# **Pearl Place Buildings 1 & 2**

**ADDENDUM IV**

**October 11, 2006**

## **Addendum #4**

#### **A1.5 Building 2 First Floor Plan**

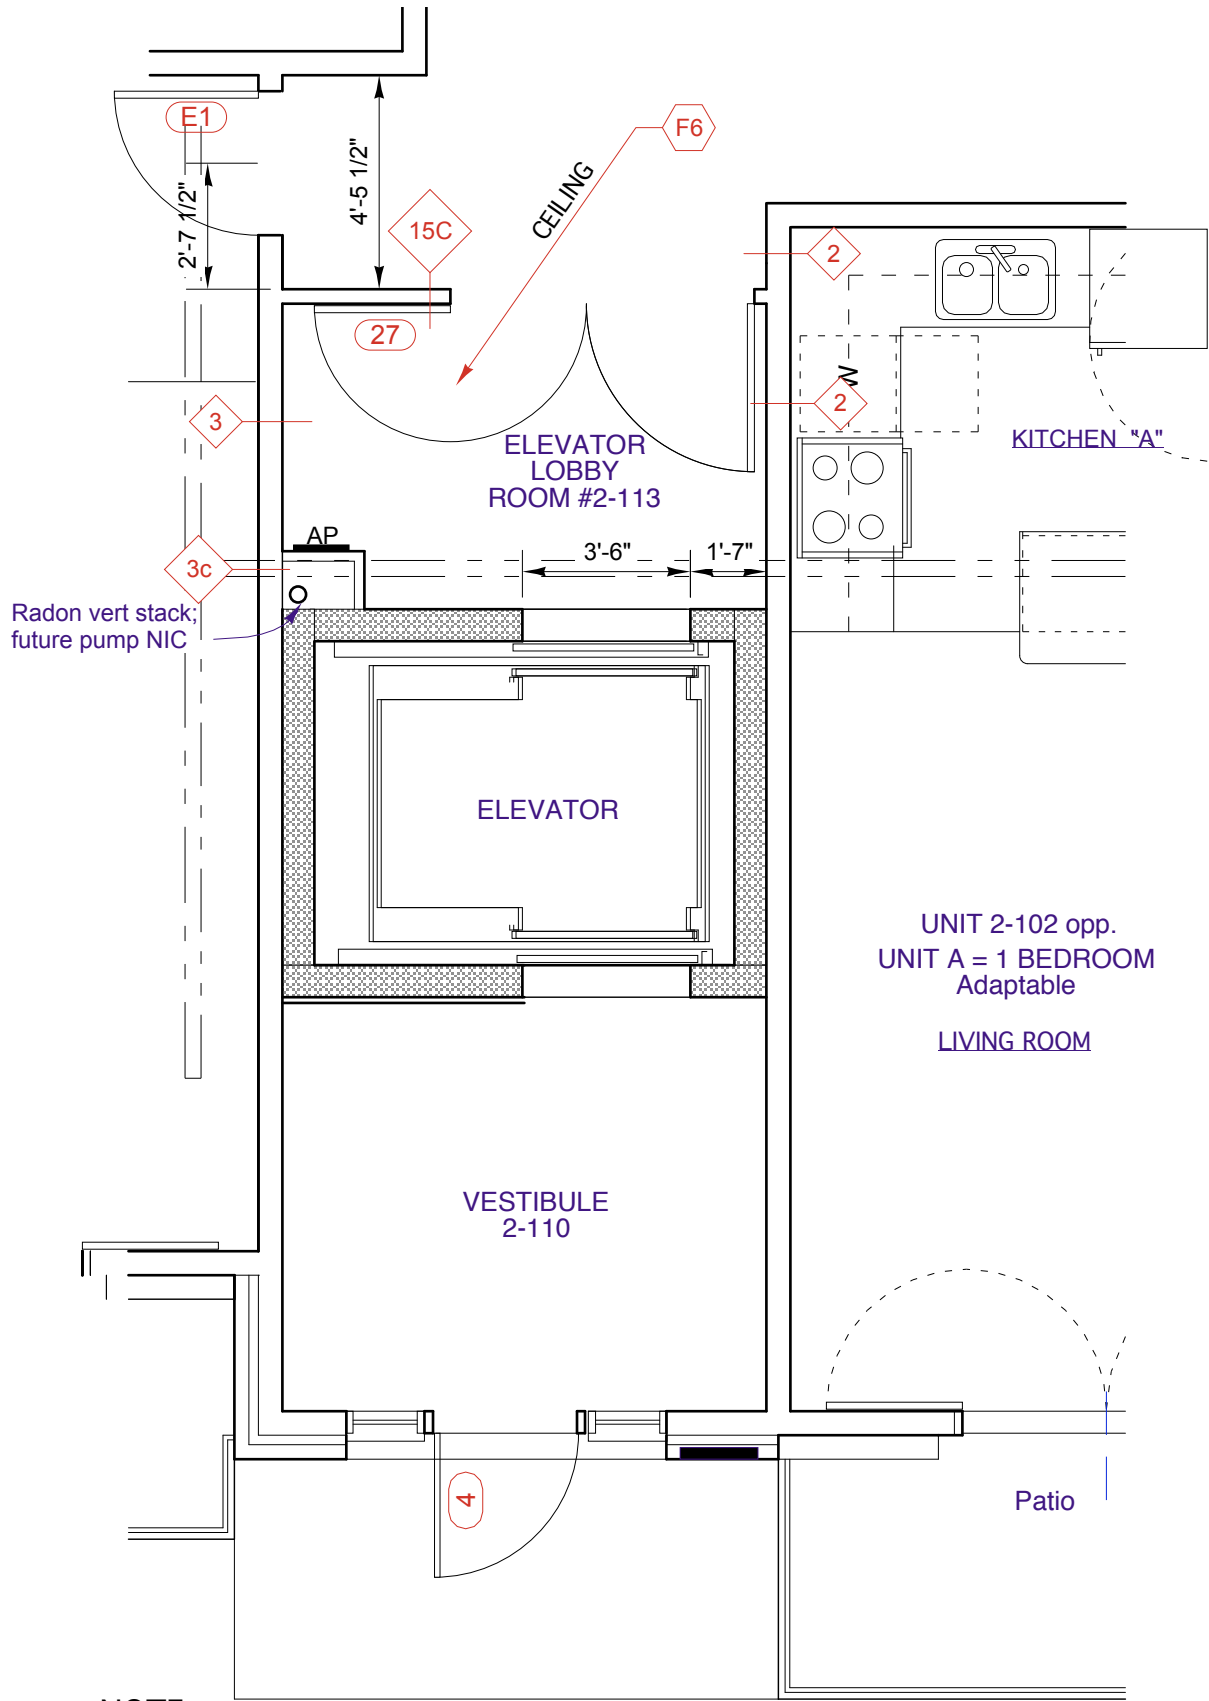
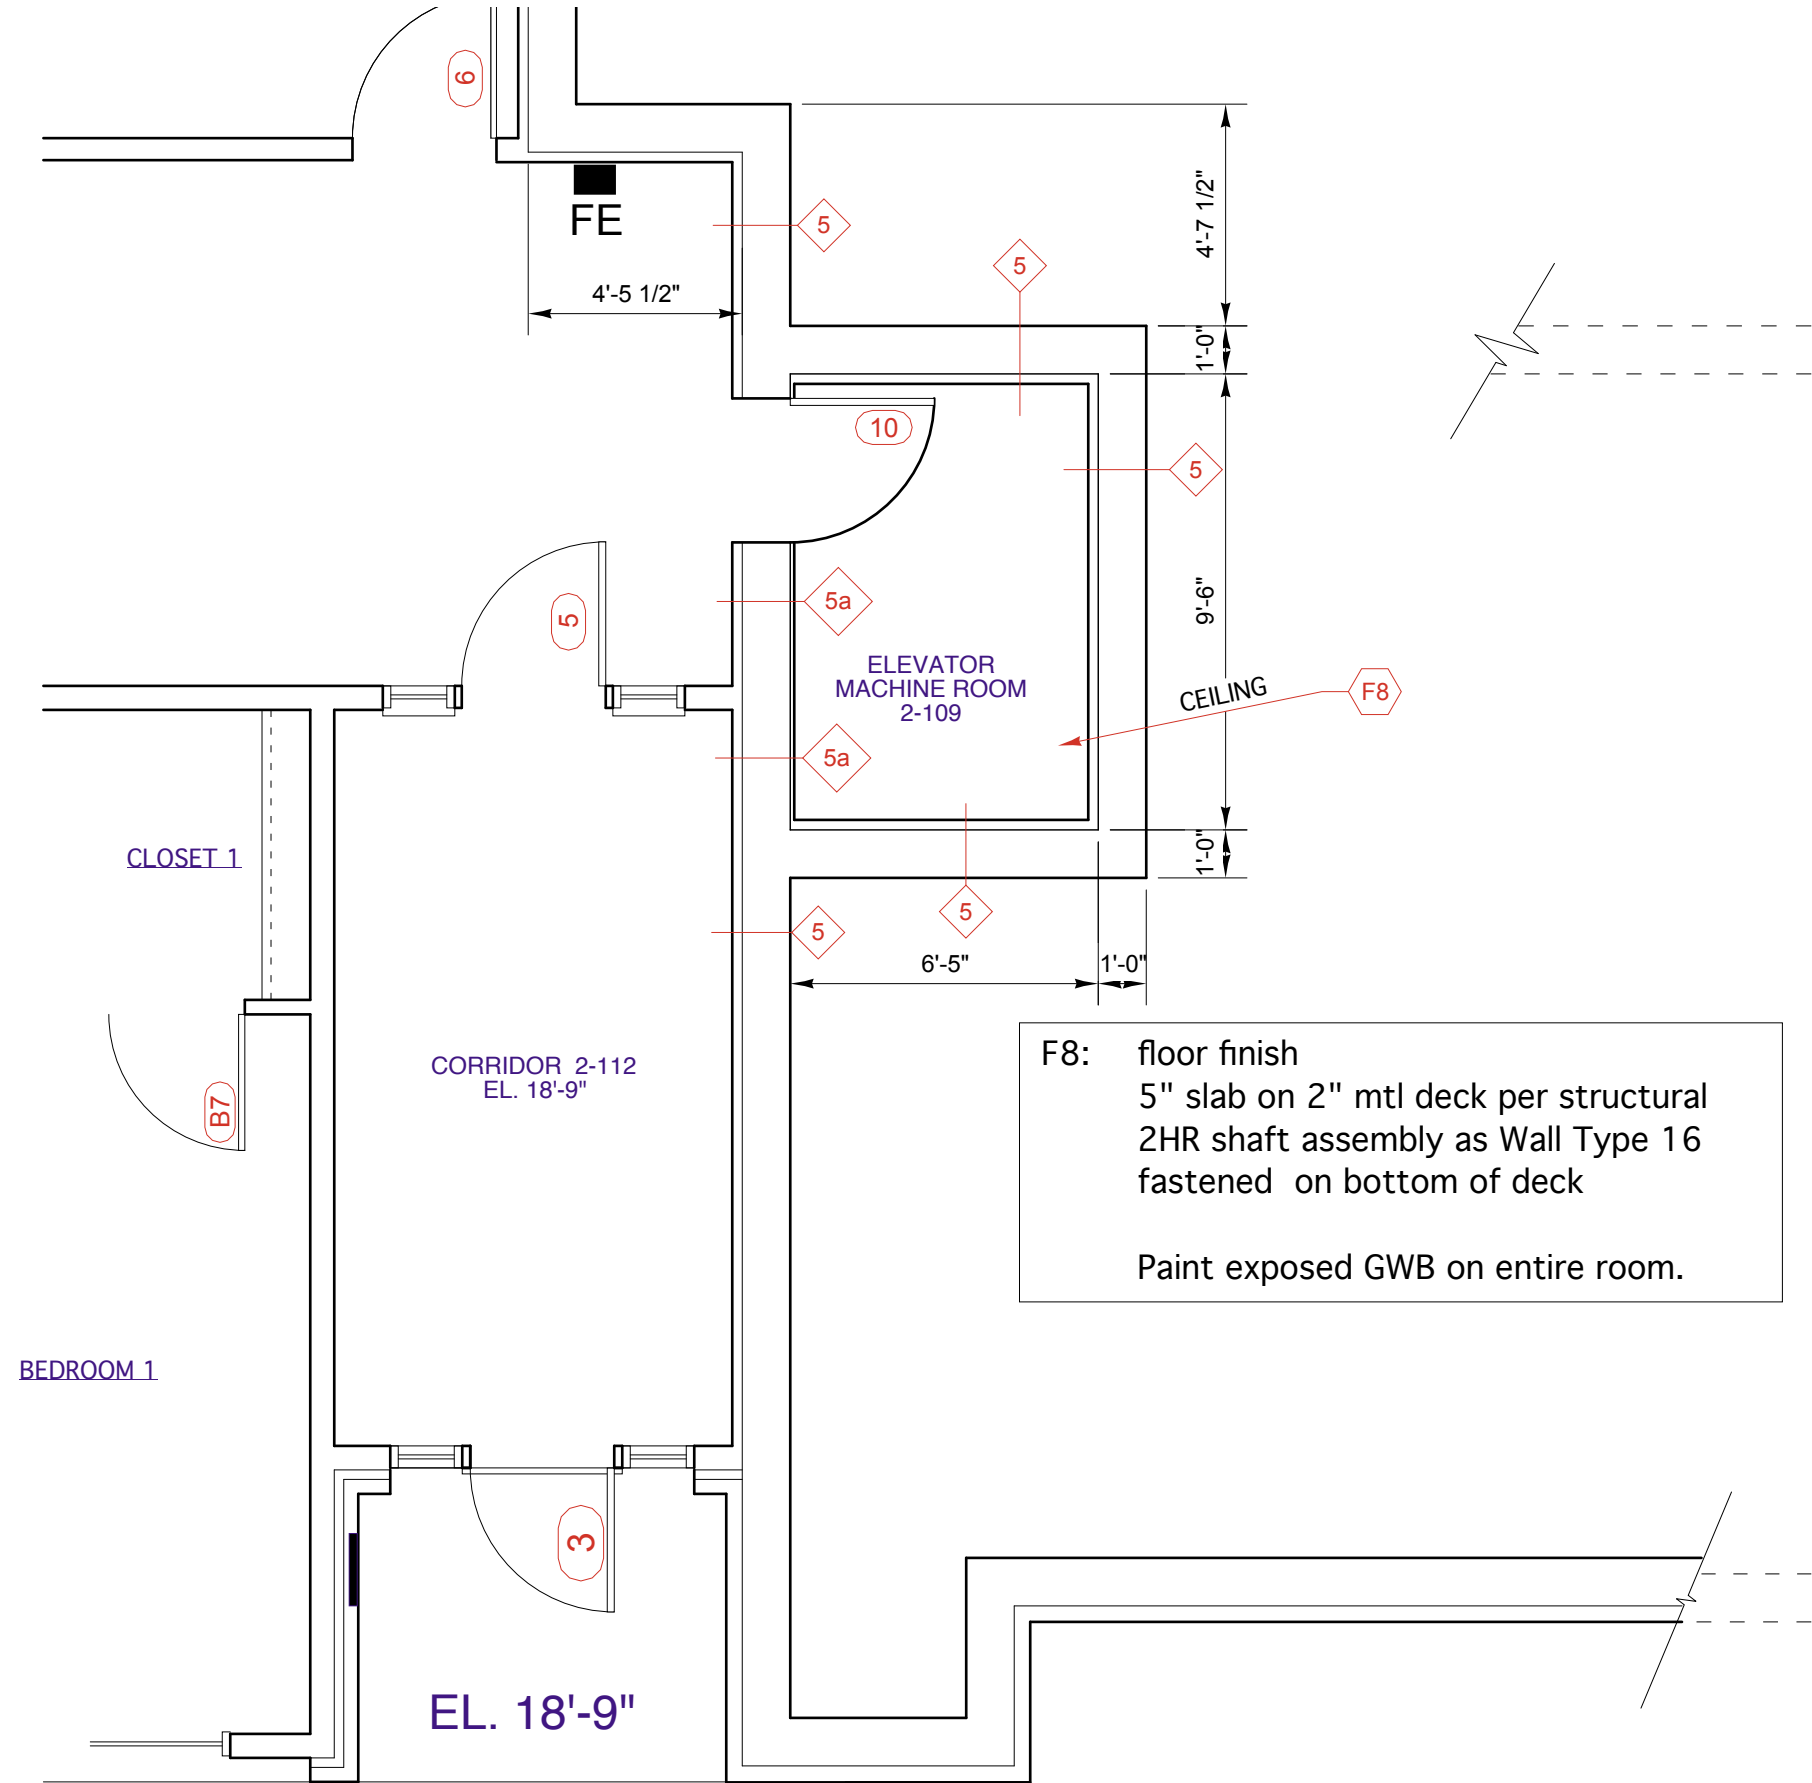
Relocate Elevator Machine Room #2-109 as shown on ASK 9 attached here. Add Elevator Lobby Room #2-113. See attached sketches for required revisions.

Delete Elevator Machine Room; add Elevator Lobby; add door 27 w/the same HW as doors 23 thru 26; new partition shall be 1HR rated; add new opening at back of elevator enclosure
